Your Ref:
Our Ref: B24120-JNP-XX-XX-CO-C-0001 P01/SLL

Re: Prickleden Mills, Holmfirth

Further to the comments received from Nick Beyer at the EA, dated 18th May 2022, below are our responses.

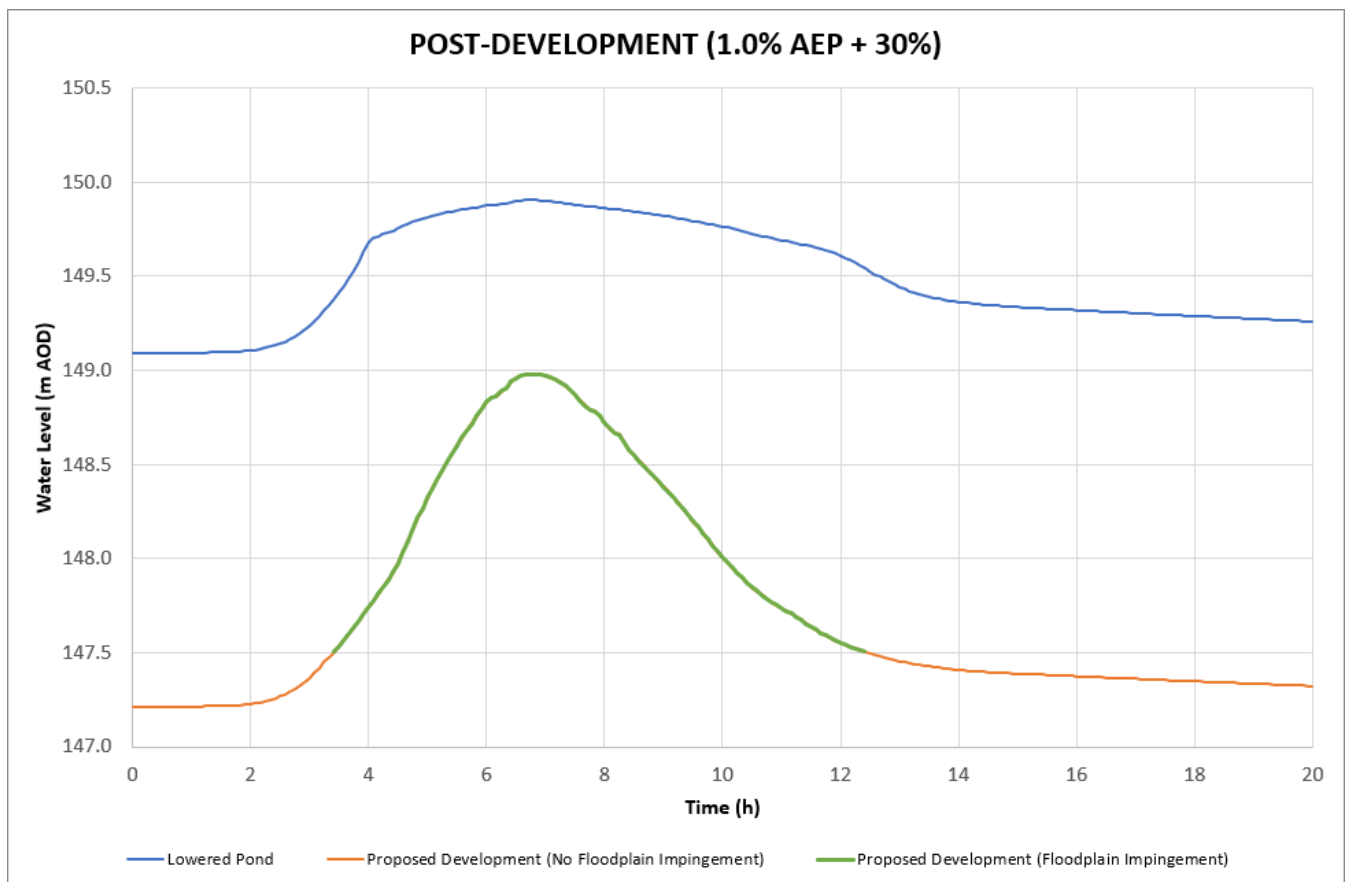
1. *Your FRA addendum says that you will provide compensatory storage volume in the mill pond by lowering the outlet level by 400mm. That would result in a baseline water level of 149mAOD. That would mean that the storage volume will become available when flood waters reach and exceed 149mAOD. In other words the compensatory storage is provided above 149mAOD. You confirmed that the ground levels where the development is proposed are generally **lower** than 149mAOD. That means that when the development is in place, it will reduce floodplain storage volume at levels lower than 149mAOD. The concern here is that in a flood event, when water starts to rise in the channel, the site where the development is will flood earlier (at lower water levels) than the mill pond storage volume will start to fill up. This means that there could be a period of time where the loss of storage caused by development isn't actually compensated for and flood water could be transferred somewhere else.*

I understood that you said, that because the river is on a steep gradient, the 149mAOD level at the entrance to the mill pond might get exceeded either before or at the same time as the lower ground, where the development is proposed. If this is the case and can be evidenced, then we no longer have an issue. If this isn't the case, then I think, as a minimum, we are looking at you needing to show what the impact of the temporary shortfall in storage would be. i.e. where would the water end up, that currently goes where the buildings are proposed? The outcome of that would dictate our view on the proposal.

2. *The FRA also says that because of the nature of the mill pond and its outlet, flood waters stored in the mill pond would recede slower than the equivalent natural floodplain. The concern here is that the storage might fill, then not be available for any potential subsequent storm event, shortly afterwards. For this, I think you will need to provide info on how long it will take for the levels in the mill pond to go back down to 149m AOD and justify that this is fast enough to not cause a problem.*

JNP response - The figure below (post-development scenario and 1.0% AEP + 30% climate change) confirms that flows get into the lowered pond throughout the period between 3 and 13 hours during which the proposed development causes floodplain impingement (i.e. flood level along site front > 147.5 m AOD), thus providing the necessary floodplain compensation.

JNP response - The figure above also shows that the lowered pond empties fairly quickly, with more than half of the pond's total volume available for a subsequent flood within 6 hours of the end of the 1.0% AEP + 30% storm (design event).
